Project/File: 160402067

**Reference: 930 & 1010 Somerset Street West
Urban Design Review Panel Report**

1010 Somerset Street West | Informal Review | Plan of Subdivision and Zoning By-law Amendment | City of Ottawa/ Barry Hobin Architecture

SITE PLAN | Proposed

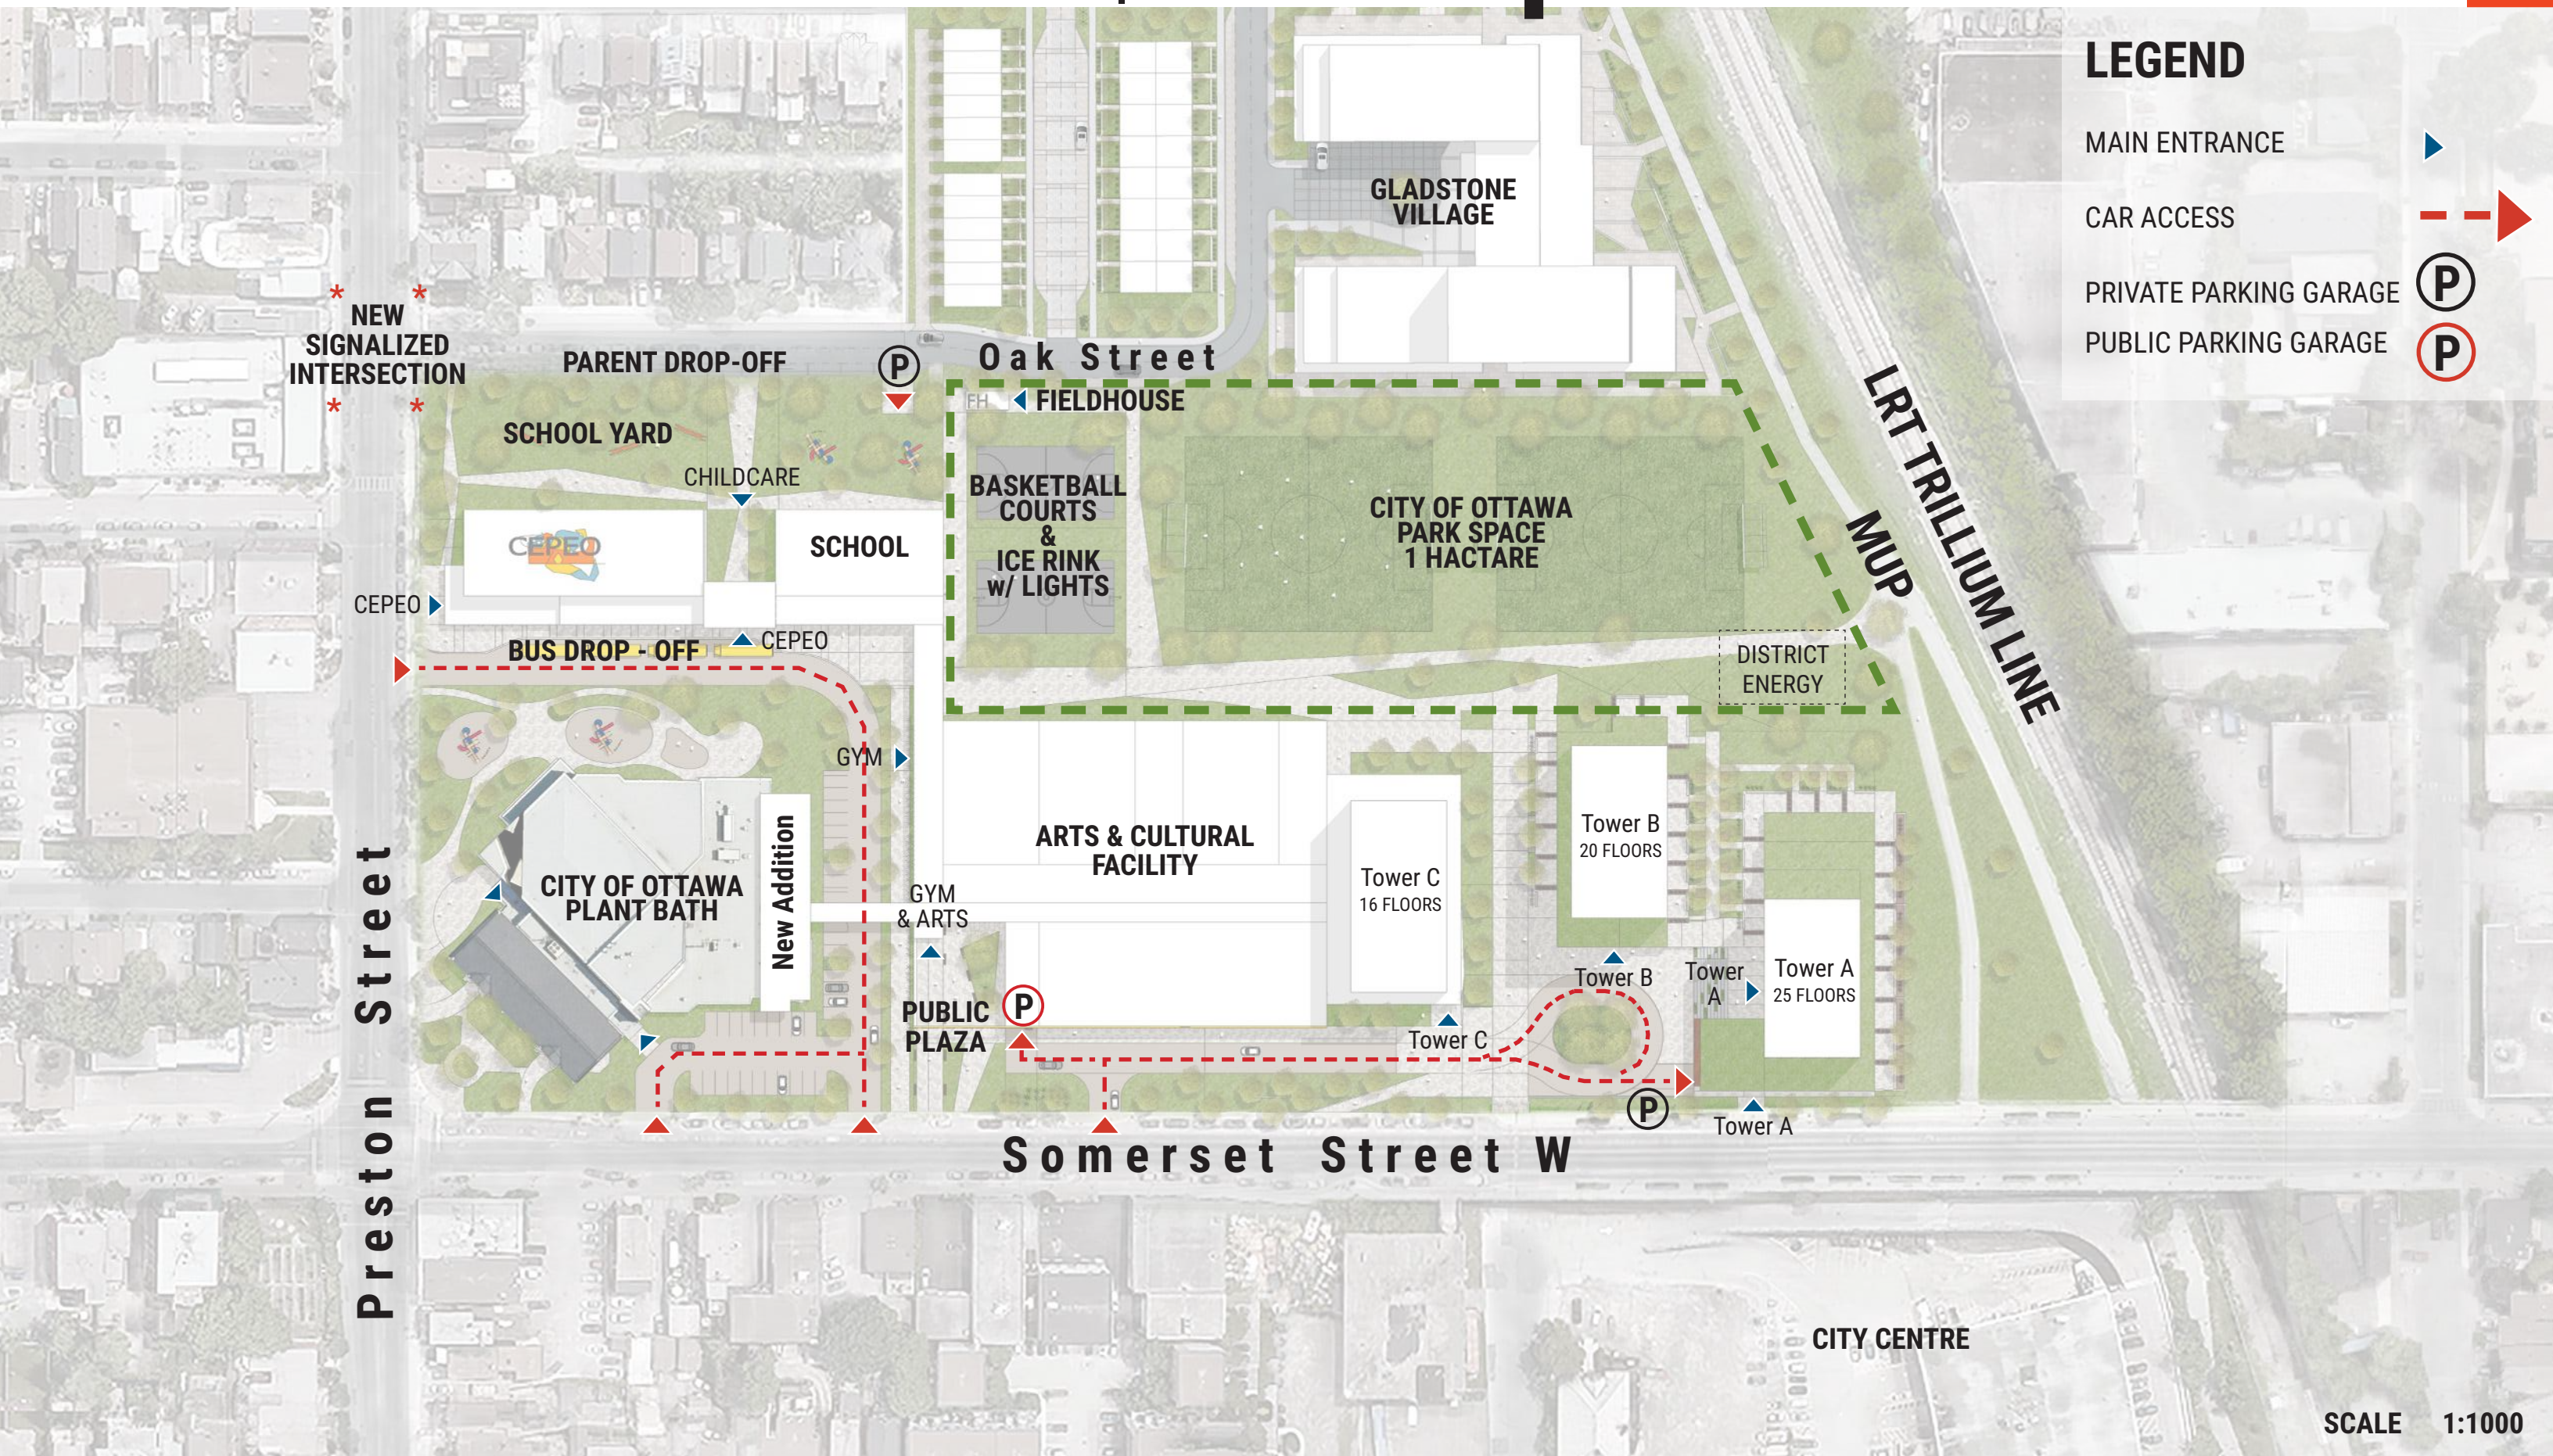
Placemaking is pivotal to the success of the project. This requires making the Public Plaza the heart of the district. This public space should be animated and tell a story.	Lands identified previously as a public plaza are currently not owned by the City of Ottawa and are occupied by two mixed use buildings. It is our understanding that the City will continue to explore the merits of acquiring these properties. The revised Concept Plan provides multiple opportunities for public gathering spaces.
The current parking garage access location abutting the Plaza is a concern as it requires the long parallel access drive in its current location. and it should be re-located.	The parallel access driveway has been removed and replaced by moving the uses to directly abut the street. Parking access is now located interior to the site.
The service lane located parallel to Somerset Street West is a significant concern. Reduction or removal of this element should be explored as it has a direct impact on the abutting public realm relationship and diminishes the importance of this main street frontage.	The parallel access driveway has been removed and buildings pulled to abut the Somerset Street West frontage.

The Panel noted the need for additional porosity given the size of the block. Suggestions included: <ul style="list-style-type: none"> • Clear language of connections and sightlines. • A stronger connection from Somerset Street to Gladstone Avenue by way of re-orienting the arts and cultural facility and providing an additional public street connection through the subject block. This would result in a primarily 	The Concept Plan moves the future residential development and RCFS to abut Somerset Street West. The Concept incorporates the existing multi-use pathway and City Centre underpass and provides active transportation linkages through the site. Somerset Street is connected to Oak Street to the south via a network of multi-use pathway linkages.

- The current parking garage access location abutting the Plaza is a concern as it requires the long parallel access drive in its current location. and it should be re-located.

- The service lane located parallel to Somerset Street West is a significant concern. Reduction or removal of this element should be explored as it has a direct impact on the abutting public realm relationship and diminishes the importance of this main street frontage.

- The Panel noted the need for additional porosity given the size of the block. Suggestions included:
 - Clear language of connections and sightlines.
 - A stronger connection from Somerset Street to Gladstone Avenue by way of re-orienting the arts and cultural facility and providing an additional public street connection through the subject block. This would result in a primarily institutional focused block on the east half of the site, and residential/parkland uses on the west half of the site.
